Technical Service Bulletin

Model AZERA (TG)

Number HRE09-81-P020-TG

Subject
FRONT PASSENGER SEAT BELT AND BTS WIRE FIXING
CLIP REPLACEMENT – B1489/B1495

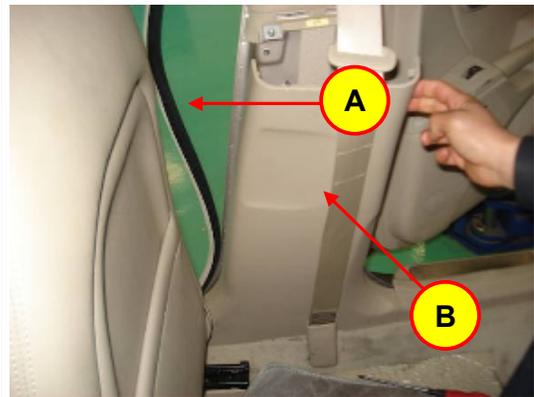
3-2. BTS wire harness fixing clip

Part Name	Part No.	Old	New
BTS wire harness clip	88883-3L000QQH

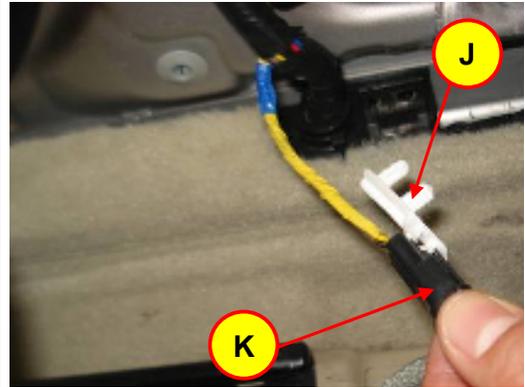
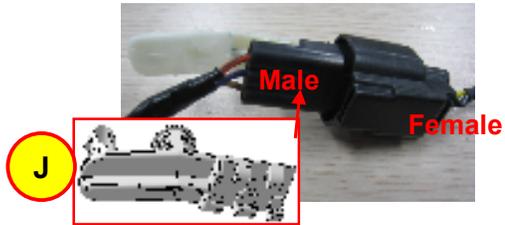
10. Remove the front passenger seat's BTS wire harness fixing clip (I).

11. Fit the newly supplied clip (J) to the male connector (K) of the BTS wire harness and reconnect the connector.

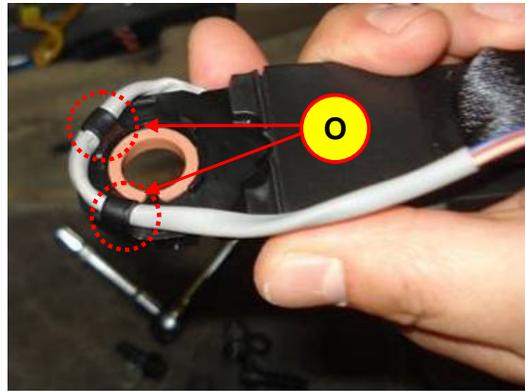
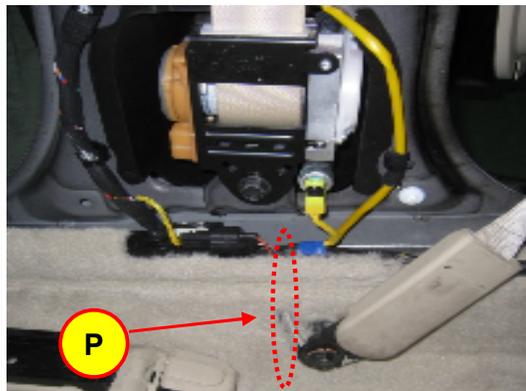
4. Pull the BTS wire harness off the guides (O).

- Use caution so that the wire protection is not damaged.

5. Remove the BTS wire guides.

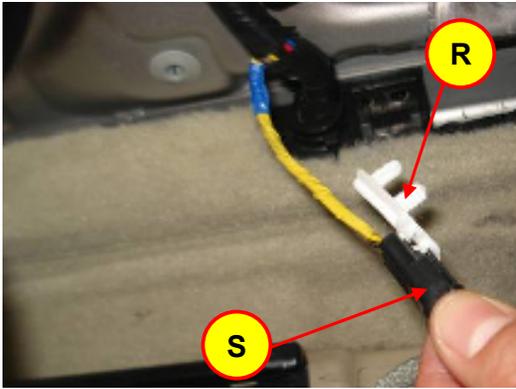
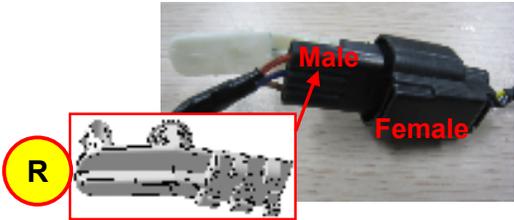
- Insert the BTS wire harness through the slot hole on the left of lower anchor bolt hole (P).

- Put the BTS wire harness below the spacer (Q) as shown in the picture and then fasten the lower anchor bolt.

8. Fit the newly supplied clip (R) to the male connector (S) of the BTS wire harness and reconnect the connector.
